UNITED STATES ENVIRONMENTAL PROTECTION AGENCY
WASHINGTON, D.C. 20460

PC Code: 123000, Isoxaflutole
Case No.: 046754

MEMORANDUM:

SUBJECT: Isoxaflutole Site Selection Report for Tile Drain Monitoring Studies and Prospective Groundwater Studies on Tile Drained Fields (447379-01).

Figure 2.—Pattern of soils and parent material in the Clarion-Webster-Nicollet association.

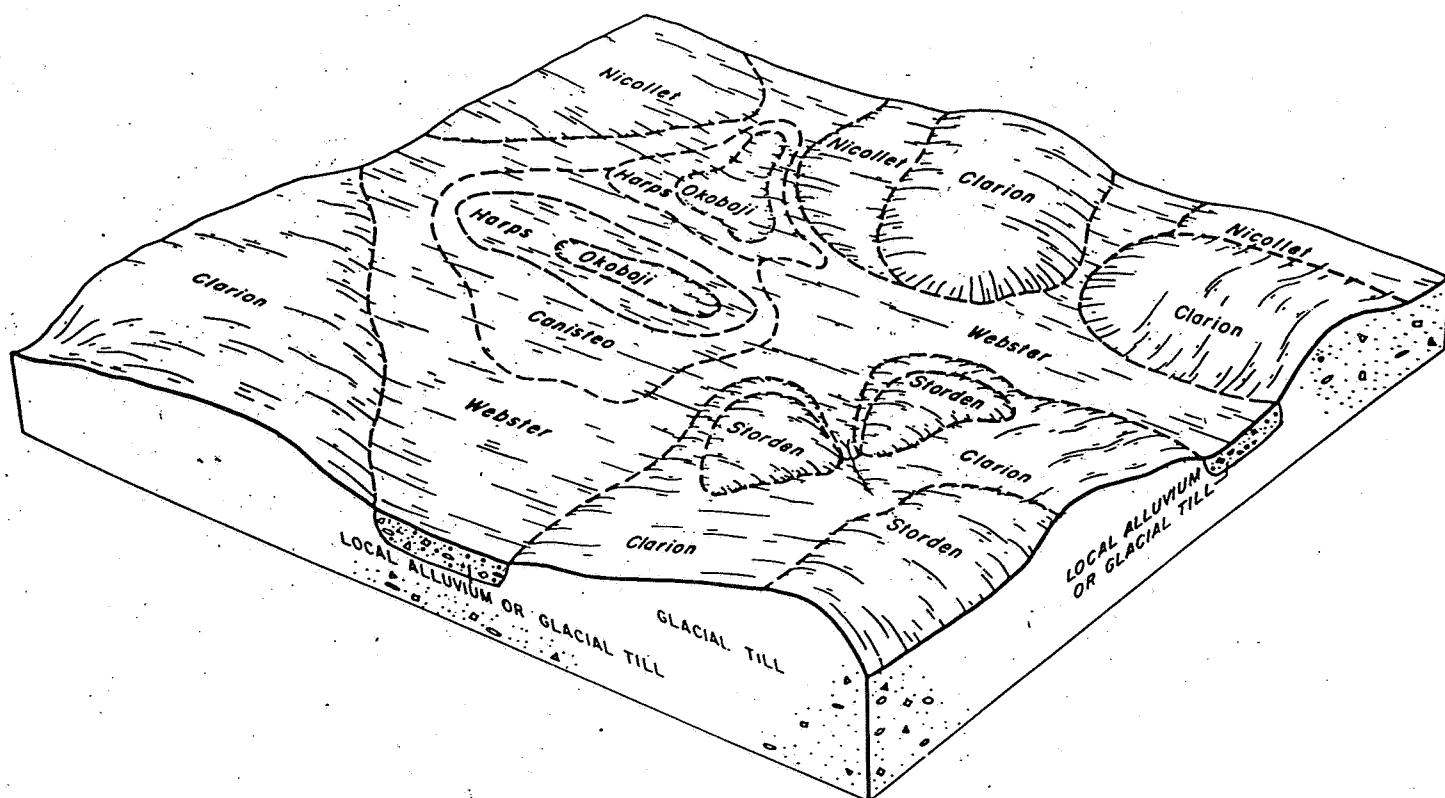
Rhône-Poulenc also did not report the drainage at the proposed sites. Drainage typical of the proposed soils is somewhat poor to very poor, but the Clarion series is well drained. Because of this, the position typical of Clarion soils at the top of rises (see attached figure) and the low water tables reported, this series makes a poor choice for a tile drain study.
